Service Bulletin

Subject: Hood Flutter, Shake or Vibration at Highway Speeds or over Rough Road Conditions

Brand:	Model:	Model Year:		VIN:		Engine:	Transmission:
		from	to	from	to		
Buick	Envision	2016	2017			All	All

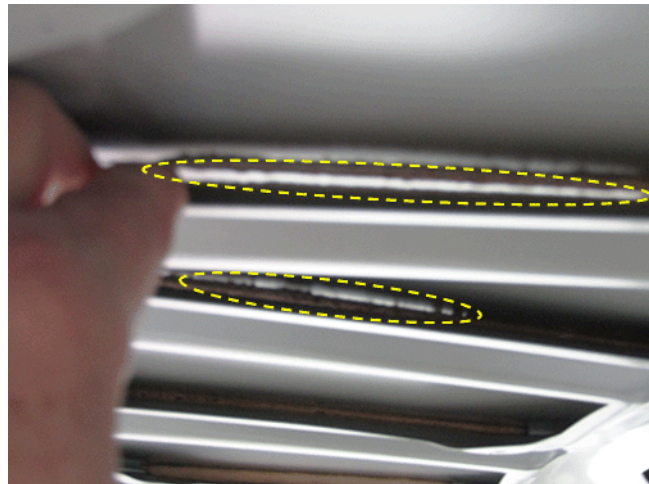
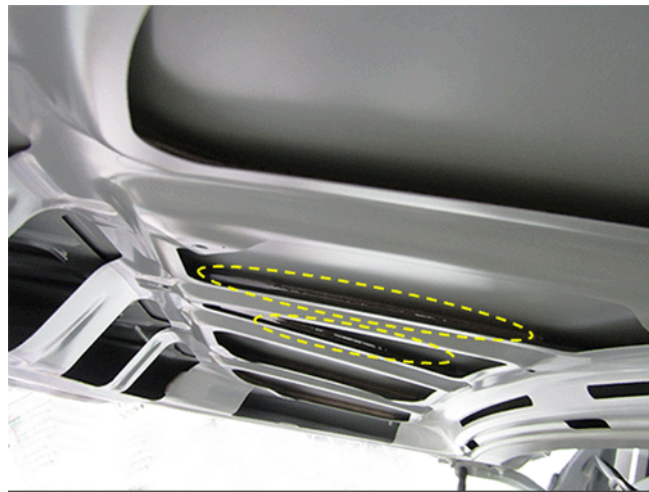
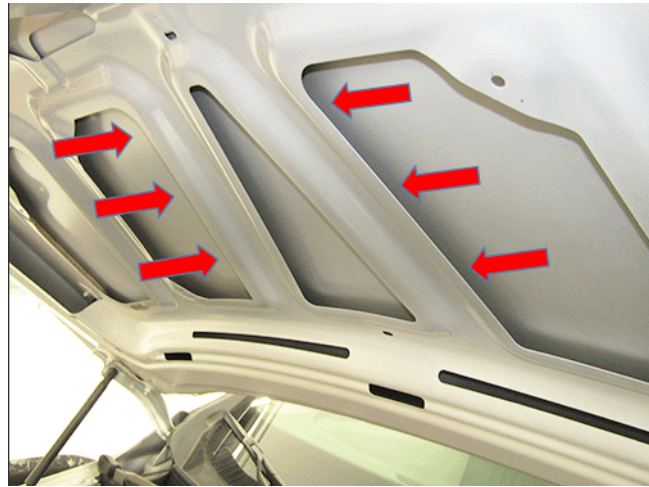
Note: As shown in the graphic examples above, the panels may show evidence of separation and/or a gap or void in the original adhesive material.

The cause of the condition may be that the inner and outer hood panels may not be sufficiently bonded together at all points. At highway speeds or over rough surfaces, the outer sheet metal may show signs of a flutter at some locations.

To prevent the metal from fluttering, apply panel vibration control material between the inner and outer hood panels, following the Service Procedure below.

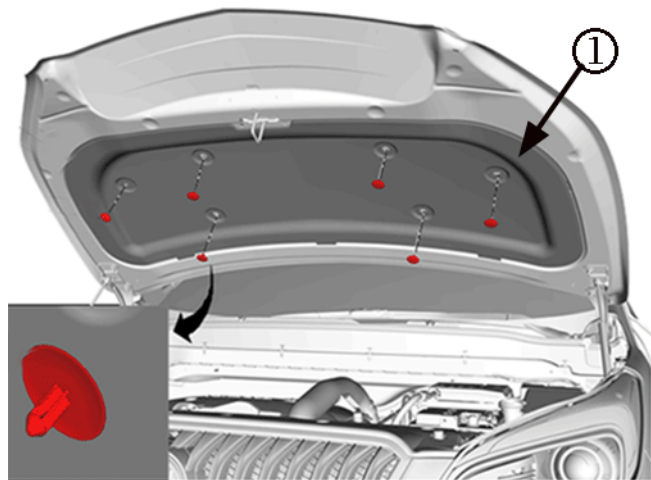
Note: The condition is most commonly found at the two center-most inner panels (1), however in some cases the next outboard inner panels (2) may also be affected.

4. The graphic above shows the areas most likely to require bonding. Examine the underhood panel for signs of original factory shrinkage or insufficient application, similar to the pictures listed in the Cause section.

Note: Application to the right side panels is shown in the graphic above.

5. Using a non-expanding two-part panel control vibration material, such as SEM 39977*, 3M™ 04274*, or equivalent, fill the voids between the inner and outer hood panels. Keep the tip of the applicator right up against the panel in order to allow the material to flow in between the panels. Follow the manufacturers instructions for proper application.
